2ND AND VIRGINIA

A new mixed-use hotel, residential, and co-working building will be located at the corner of 2nd Avenue and Virginia Street in downtown Seattle. The building will be a vibrant addition to this key intersection and will take design cues from the existing landmark on site and the urban patterns of buildings and pedestrian experiences that make up the Belltown neighborhood.

RESPONSE TO BOARD GUIDANCE

5 2ND AVE. INTERACTIVE ENTERTAINMENT SPACE

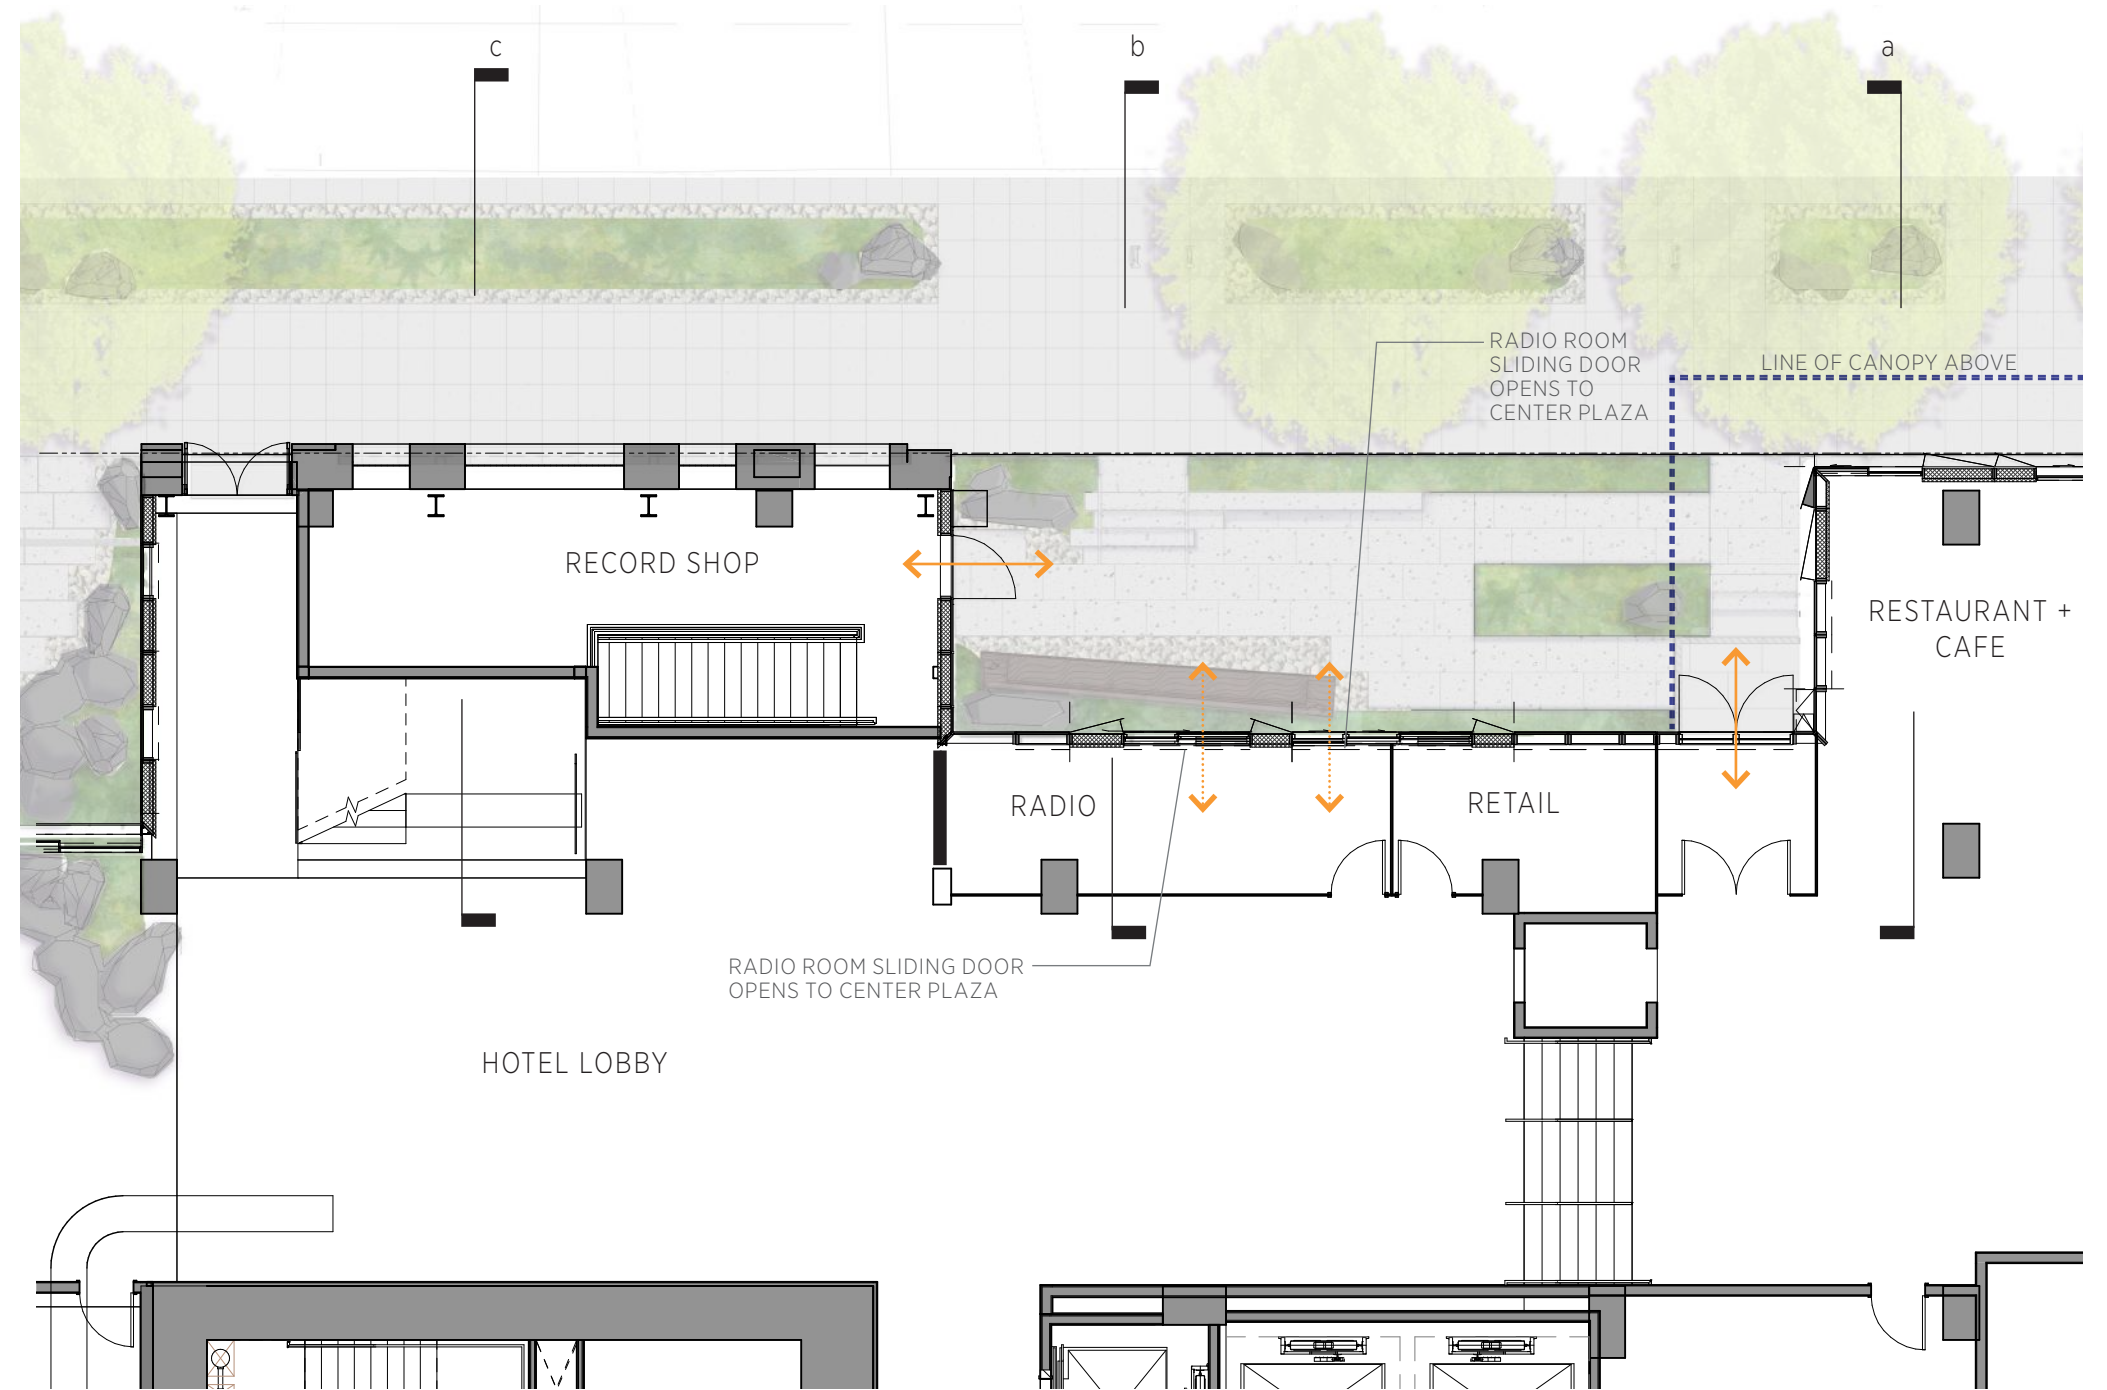
The Board was intrigued by the proposed interactive entertainment space (potential radio station use), and would like more information on what physical design features are proposed to support this use and space as an activated and engaging use along the street. The response should demonstrate how the design will remain engaging and active if this use changes.

The ground floor encourages foot traffic in and out of the building by bringing downtown amenities (a coffee stand and restaurant) to workers, visitors, and residents alike. Open space and seating, framed by lush native plantings, promote use of the plaza by the public and provides spaces to meet or relax while listening to live broadcasts from the Radio.

As well, by extending the sidewalk paving pattern into the plazas, the project widens the sidewalk at these Strategic moments of the ground floor, easing the transition. Finally, full height, sliding glass panels at the Radio strengthen the connection.

6 ALLEY GLASS CORNER

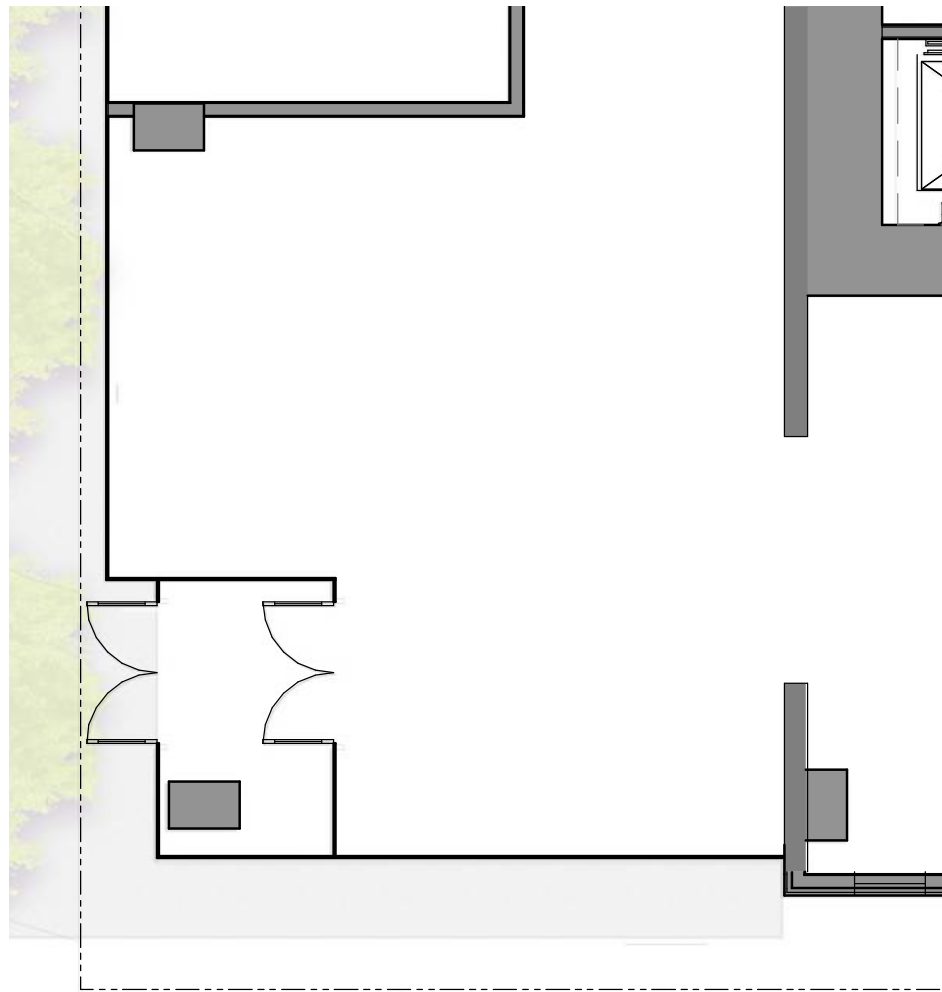
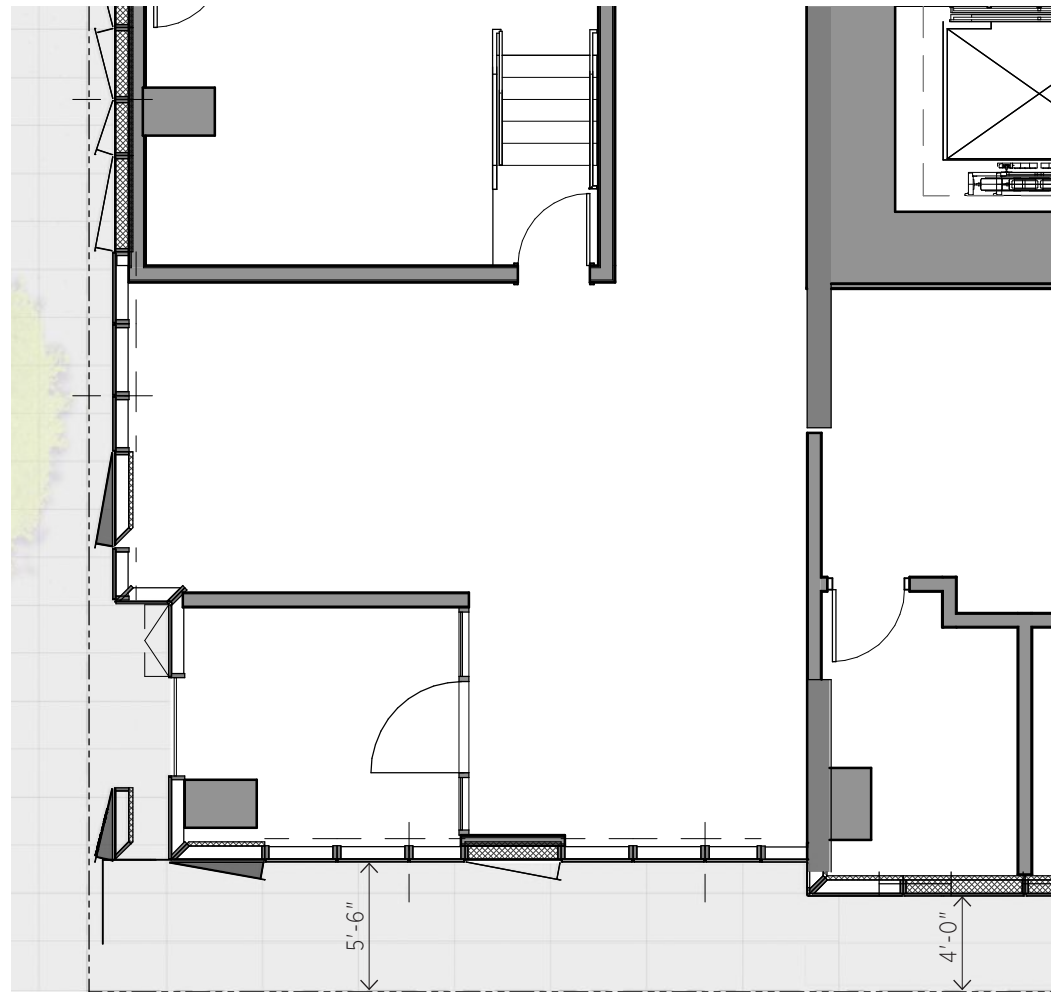
The Board gave guidance to further look at practicality of the glass corner and indicated whether this material would require bollards or column to protect the corner.

The design has evolved since EDG to remove the glass corner and have a solid, protected corner at the alley entry.

7 ALLEY ARTICULATION

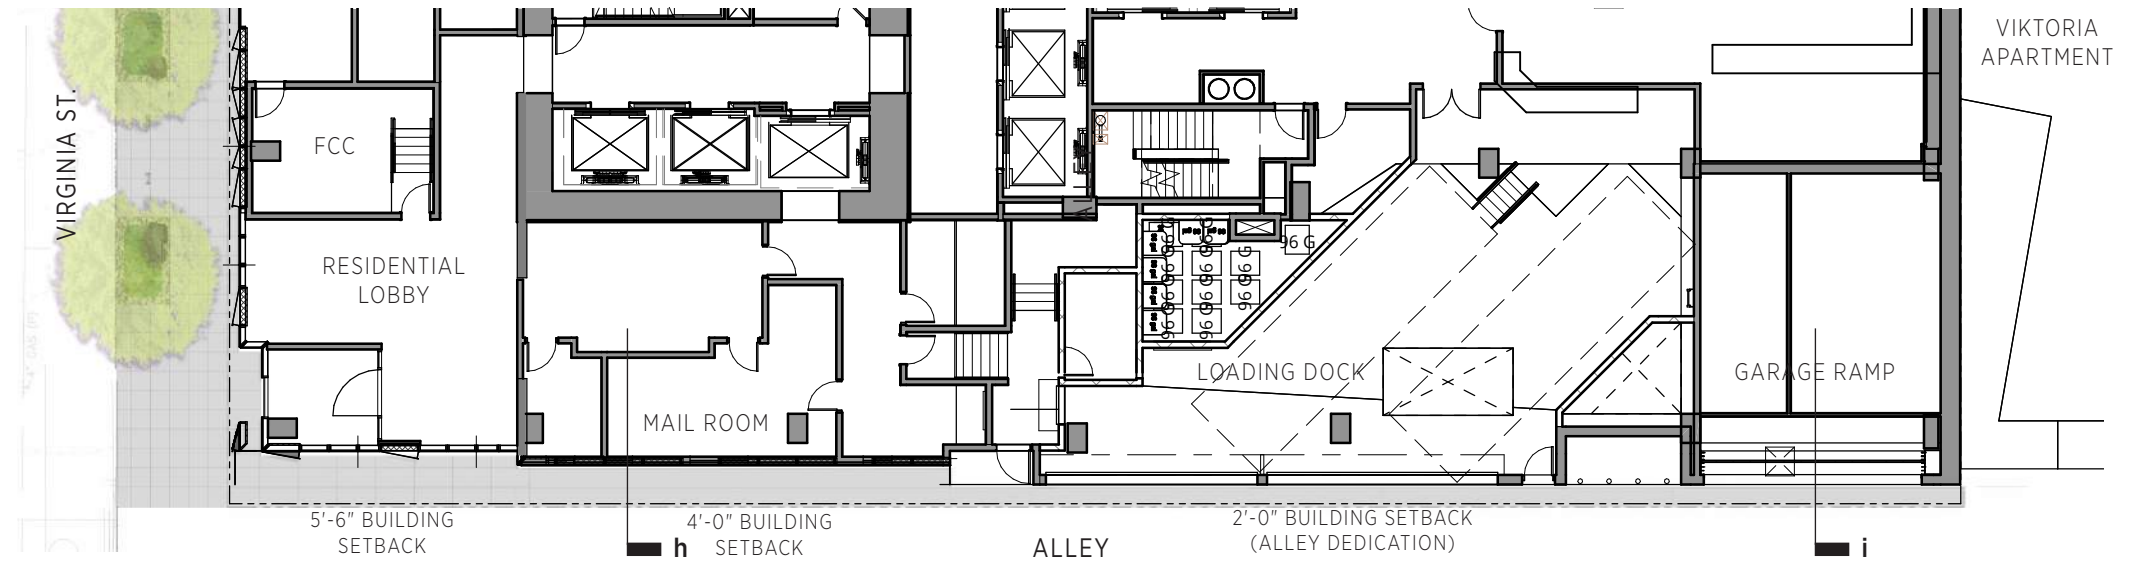
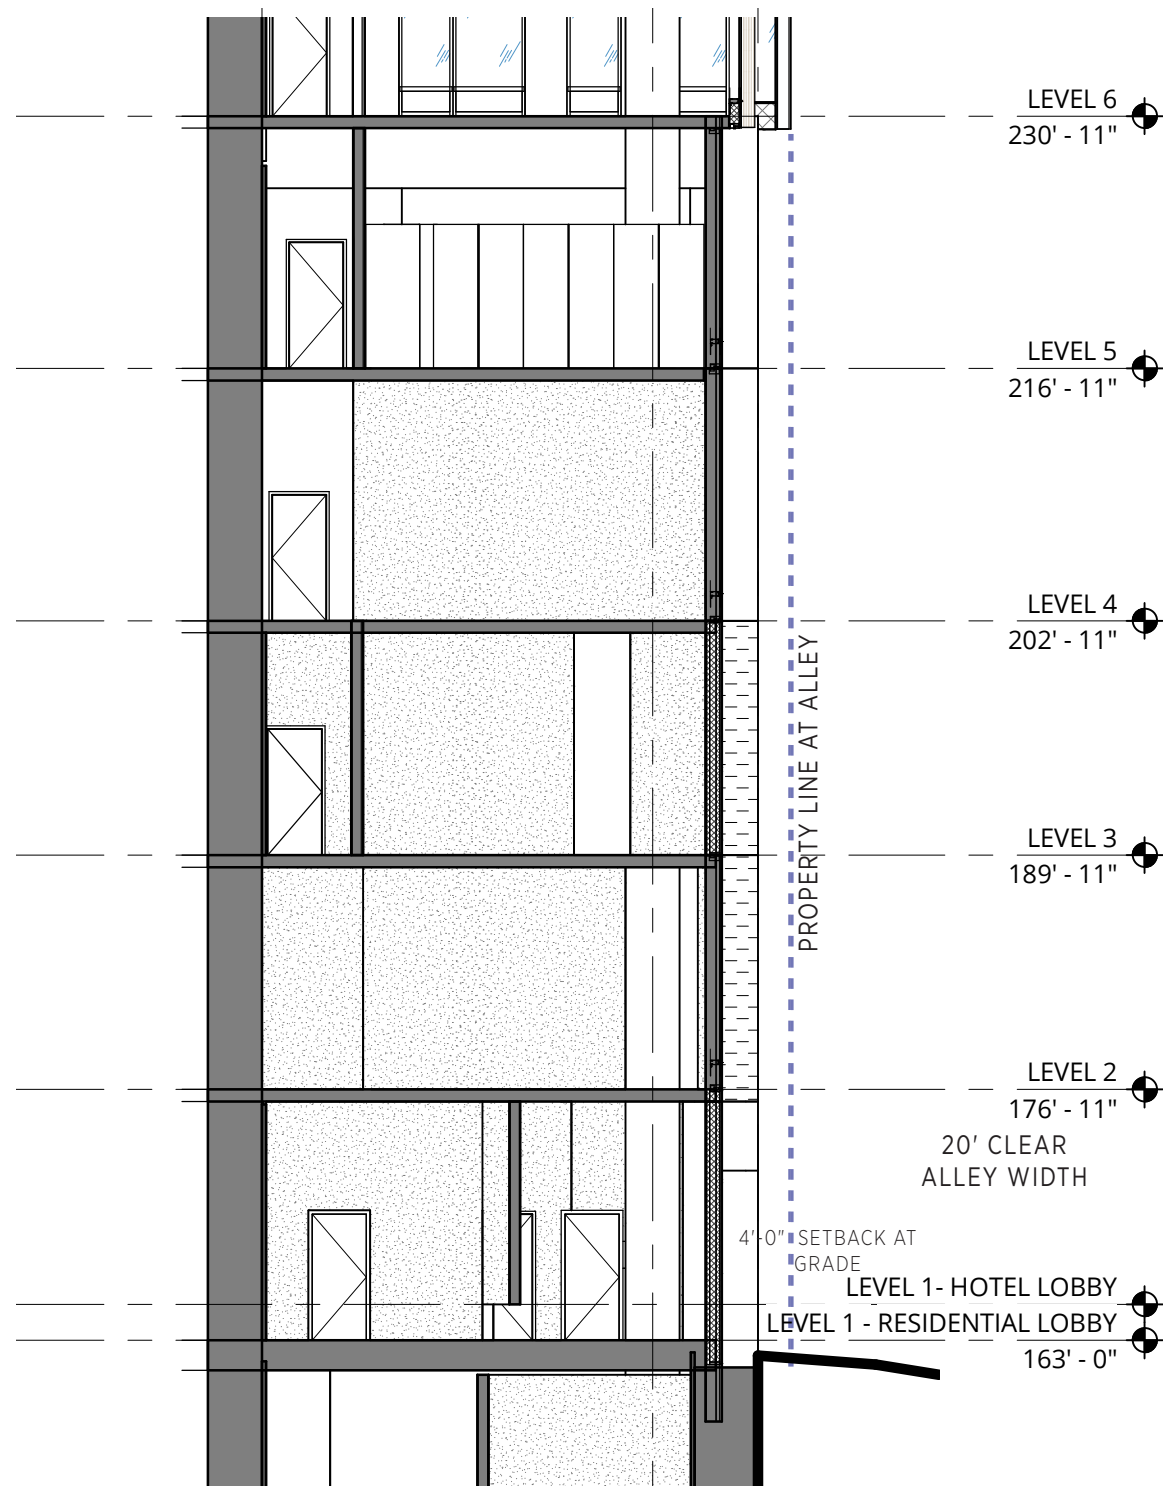
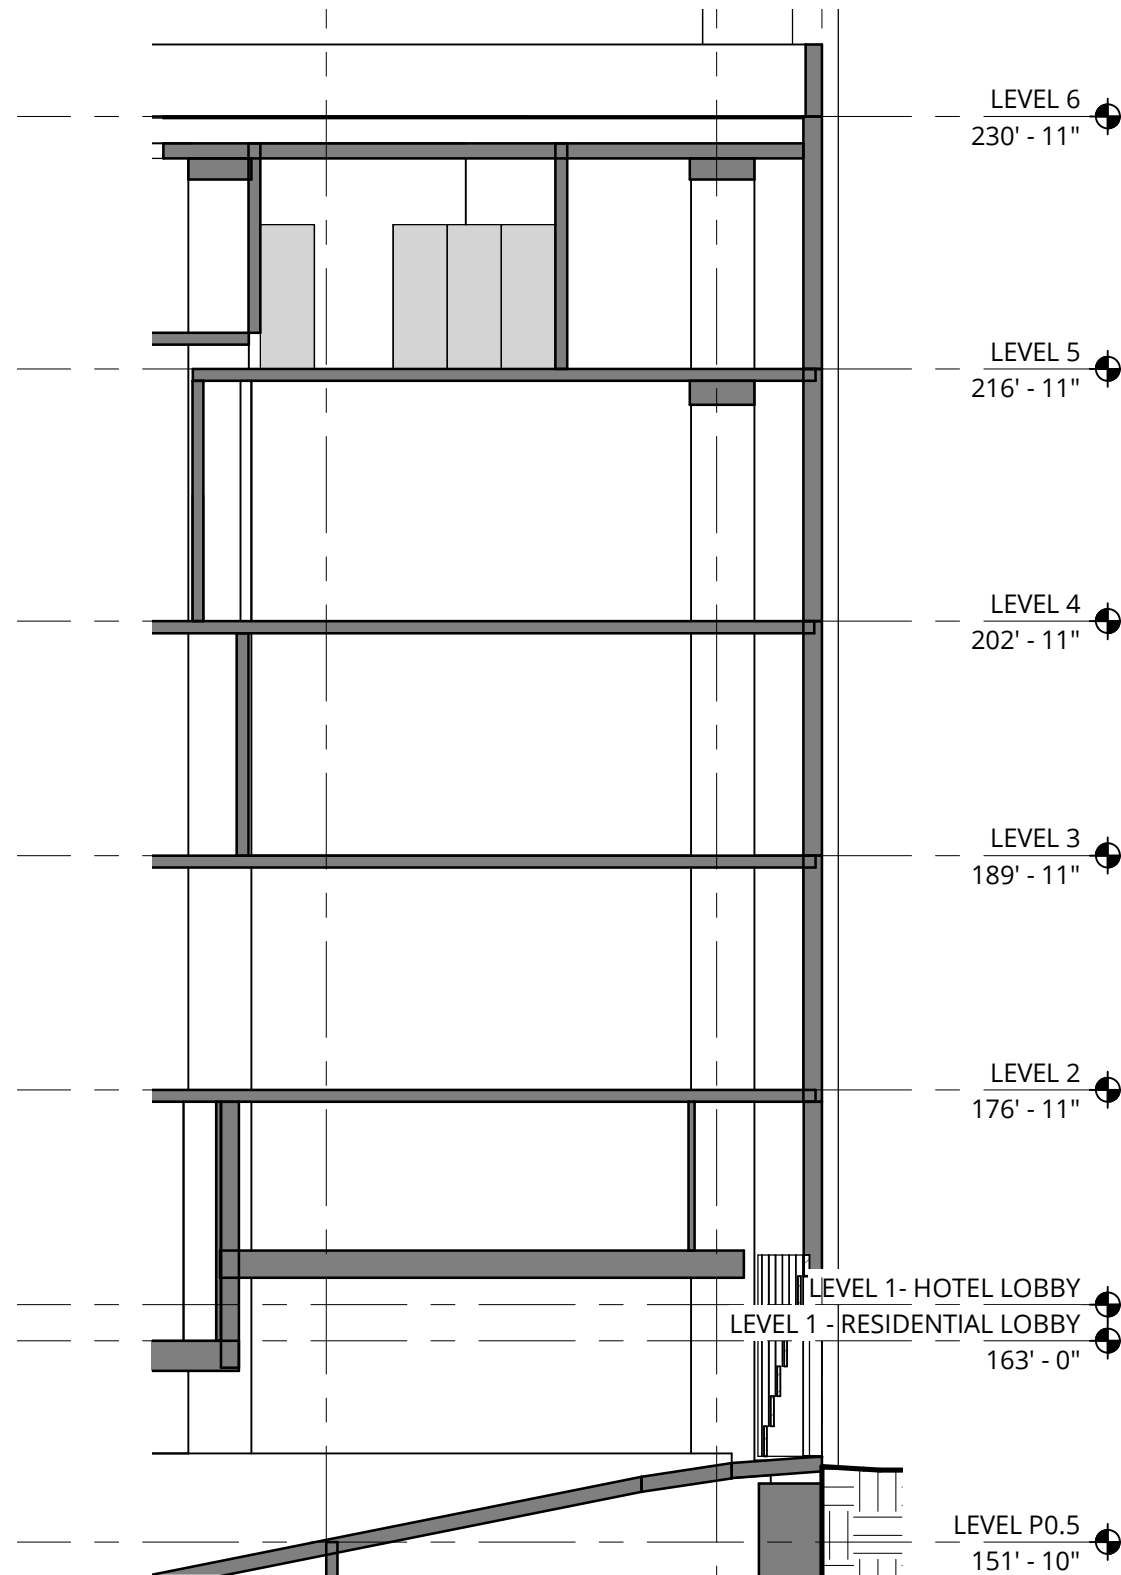
The Board acknowledged the utilitarian use of the southwest corner, however, requested more information on how the articulation of the alley will reinforce the overall tower concept. Specifically, the Board requested the design of the loading dock doors be considered.

The design of the alley is very much an extension of the overall tower concept. At the northwest corner, the tower articulation comes all the way down to the ground. Moving into the middle of the alley, the design transitions to capture the footprint of the Terminal Sales Annex before becoming more utilitarian on the south. The loading dock doors will be high-cycle, vertical stacking, sectional doors. An image is provided on the next page TSA facade provides new transparency at ground floor.
